PREVOST

WARRANTY BULLETIN

WB15-13

DATE :	MARCH 2015	SECTION :	16 - Suspension
EXPIRATION:	MARCH 2017		
SUBJECT :	IFS LEVEL VALVE CONTROL ROD POSSIBLE CONTACT

Figure 2

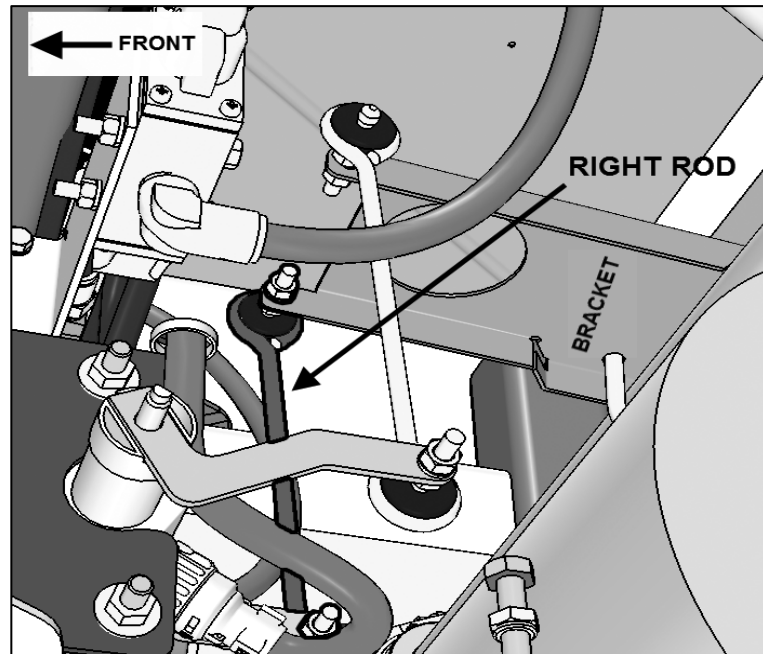
On the independent front suspension level valve linkage of the vehicles affected by this bulletin, a control rod may come in contact with an air reservoir outlet when vehicle rises from Low to High Buoy. As a result, the vehicle may be leveled higher in "Normal" position.

2. In the middle of the sway bar you will find a bracket clamped on the tube. The bracket supports two control rods (Fig. 2)

The interference is corrected by changing the side on which the rod is attached to the linkage.

Figure 3 : Flip upper and lower connection of control rod.

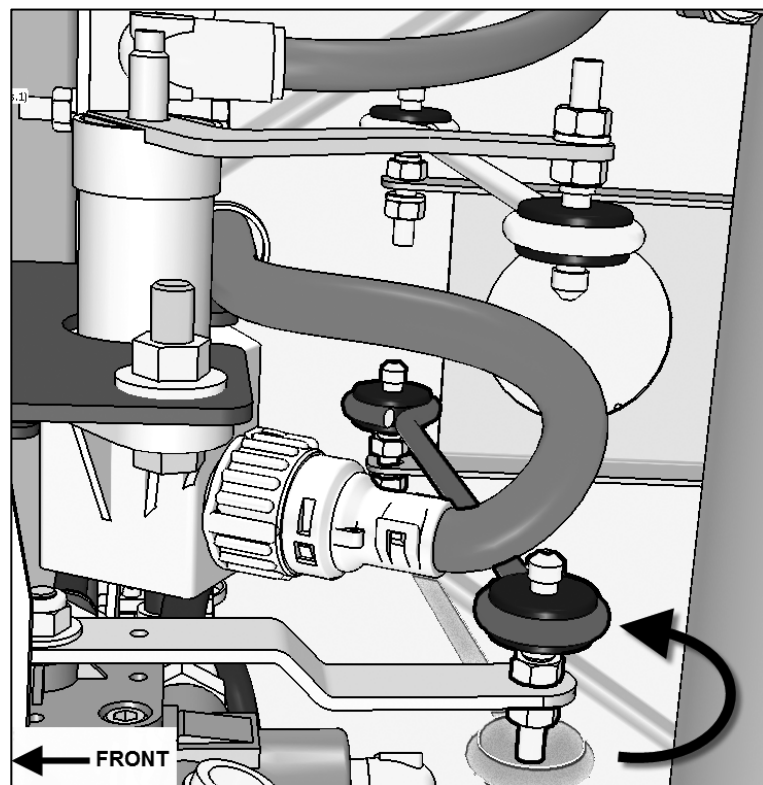
3. On the right hand side rod. (Fig.2) Unscrew the upper and lower mounting nuts.
4. Flip the rod over to the opposite side of the control lever and bracket tab above. (Arrow, Fig. 3)
5. Re-assemble hardware. (Fig.3)

Figure 4

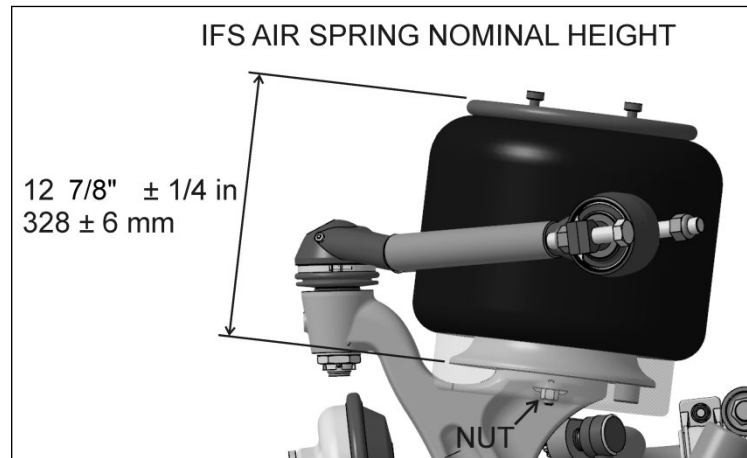
6. Adjust ride height to 12 7/8" ±1/4". (328mm ±6mm)
